To: Steele, Tania (SD)
Subject: Municipality of Harrison Park - Sandy Lake Water Level Control Project File: 5804.00

Re: **Sandy Lake**
 Water Level Control Project

This letter is written to address the three outstanding comments from the public and Technical Advisory Committee review of the Sandy Lake Water Level Control Project EAP.

R.M. OF HARRISON: SANDY LAKE
 WATER LEVEL CONTROL PROJECT
 OUTLET SECTION

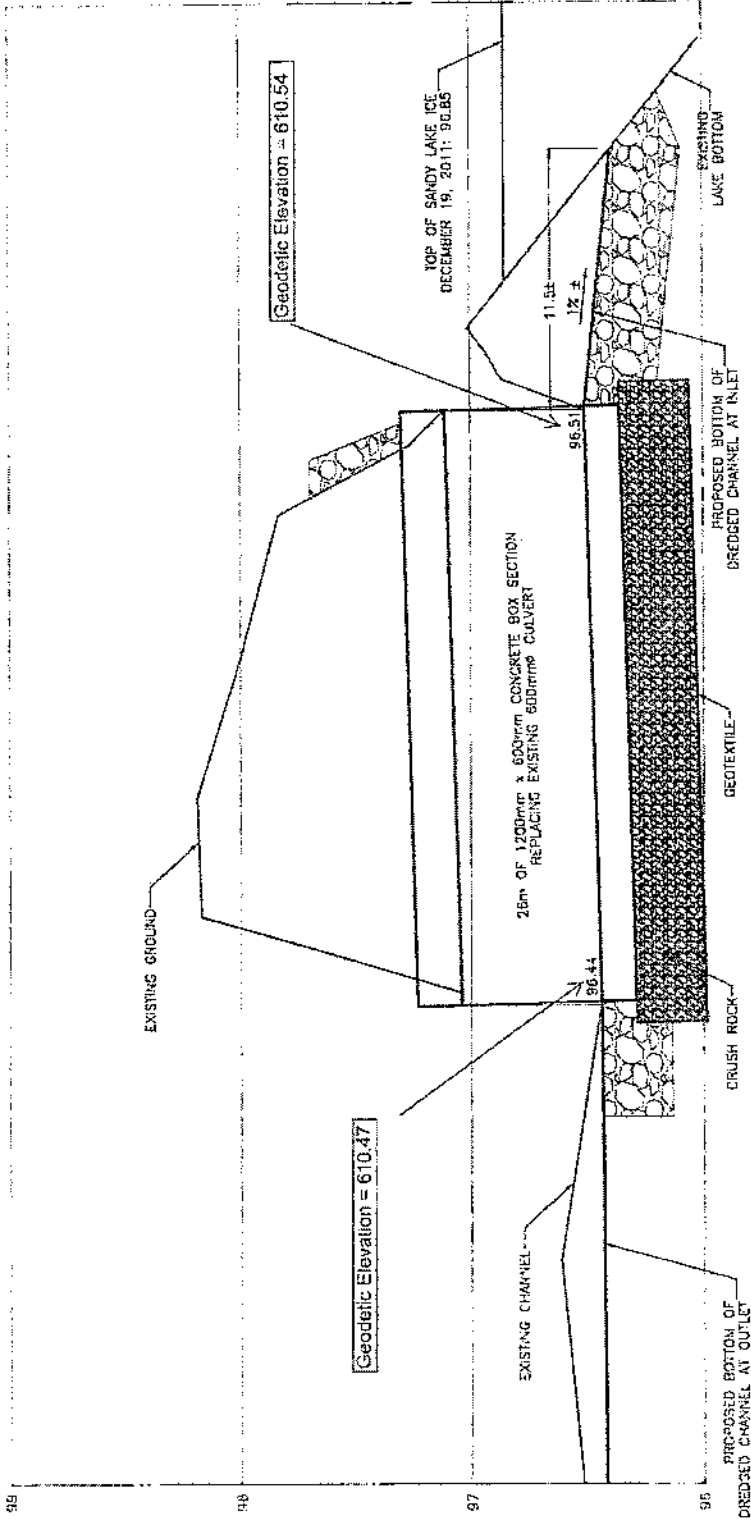
1. The proposal references a target water level for the lake to the main community dock (0.1 m below the top of the dock). I understand the dock has since been removed. A geodetic level for the target elevation is needed. Are there plans to establish another convenient reference point for monitoring water levels?

An engineered drainage plan and design of proposed infrastructure are required, as per the attached specifications.

The geodetic elevation of the top of the main pier was at 611.03. The goal is to lower the lake level to 0.1m below the top of the main pier to an elevation of 610.93.

The target water level of 0.1m below the top of pier was just used as an easy reference for the public. During survey and construction, numerous benchmarks will be available to be used as a reference point for monitoring water levels.

Rick Pemkowski, the local water resource officer, was contacted regarding the need for an engineered drainage plan. He stated that all he would need, aside from the stamped plans included in the EAP, are geodetic elevations for the proposed culvert and the target water level. See the attached Drawing for the relevant geodetic elevations. A copy of the attached drawing has been forwarded to Rick Pemkowski.

Geodetic Elevation
 Top of main pier = 611.03
 Target water level (0.1m below top of main pier) = 610.93
